UNITED STATES PATENT AND TRADEMARK OFFICE

Office Action Summary

10/755,494

DETAILED ACTION

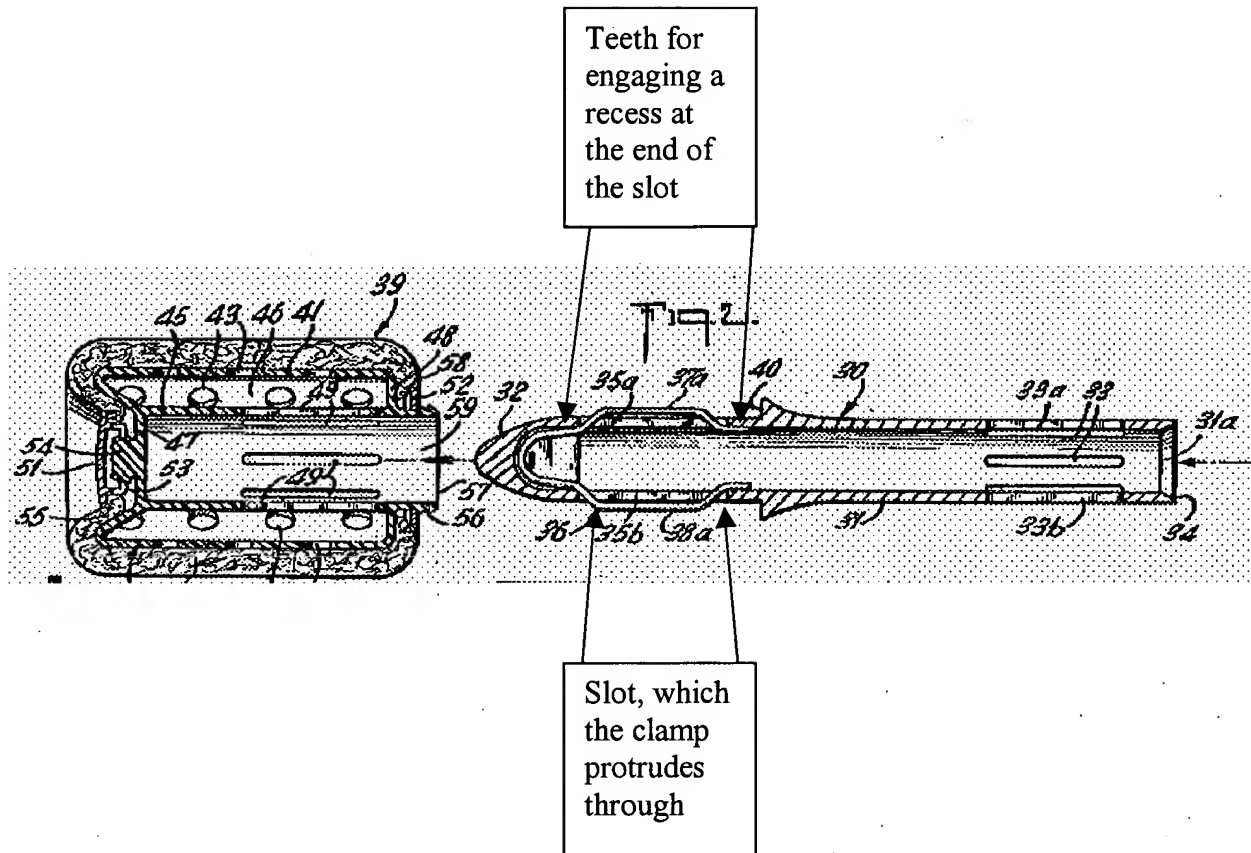
Teren teaches a cleaning apparatus comprising a cleaning element support (30) for carrying the cleaning element (39) about a sidewall of the support. The support is cylindrical. There is a handle (15) coupled to the support wherein the handle is rotatably coupled to the support. There is a powered drive means (not labeled) carried in the handle having a rotatable output shaft for rotating the support upon activation of the power drive means. There is a clamp means (36) on the support for clamping the cleaning element in a fixed position on the support. There is a slot formed along the support for receiving the clamp means (see figure below). The cleaning element has an exterior surface (41) with cleaning members (42) fixed thereto and radially projecting therefrom. The opposed ends of the cleaning element are spaced apart from each other when the cleaning element is mounted on the support. The cleaning element extends over substantially an entire surface of the support. There is a container (46), which defines the support, for carrying fluid and apertures are formed in the container for dispensing the fluid from

the container. The clamp means comprises a first and second end (see figure below) for selectively engaging recesses formed at either end of the support slot.

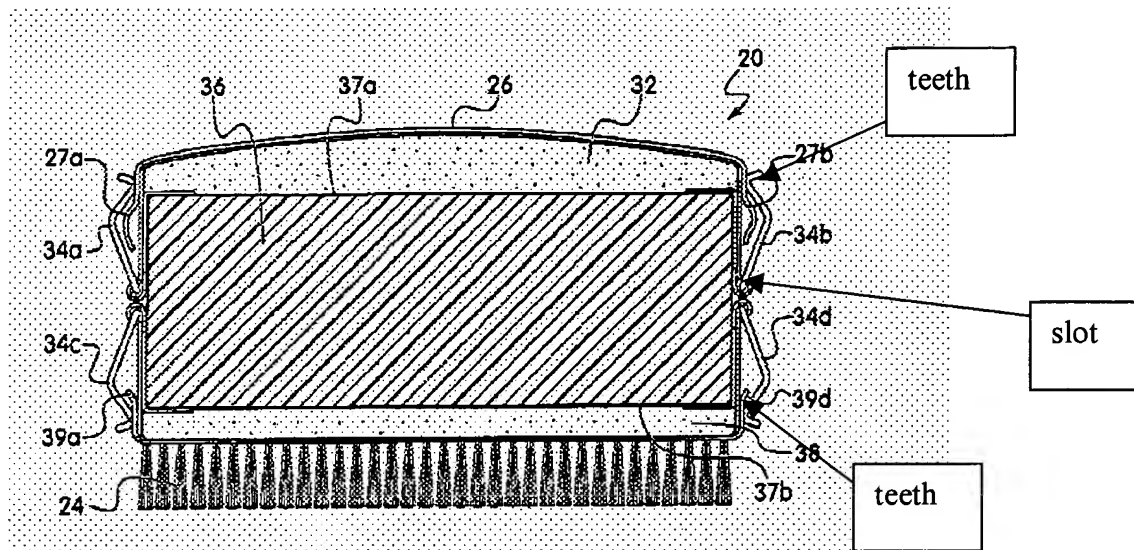
Applicant's arguments filed 5/9/05, with respect to Teren, have been fully considered but they are not persuasive. Examiner notes that the cleaning member (39) in Teren includes the scouring pad (42) and the tool member (44). On figure 2, the cleaning member is the entire drawing on the left side of the figure. The support member is indicated as reference number 30. Therefore the clamps are located on the support member and are used to secure the cleaning member (scouring pad and tool member) to the support.
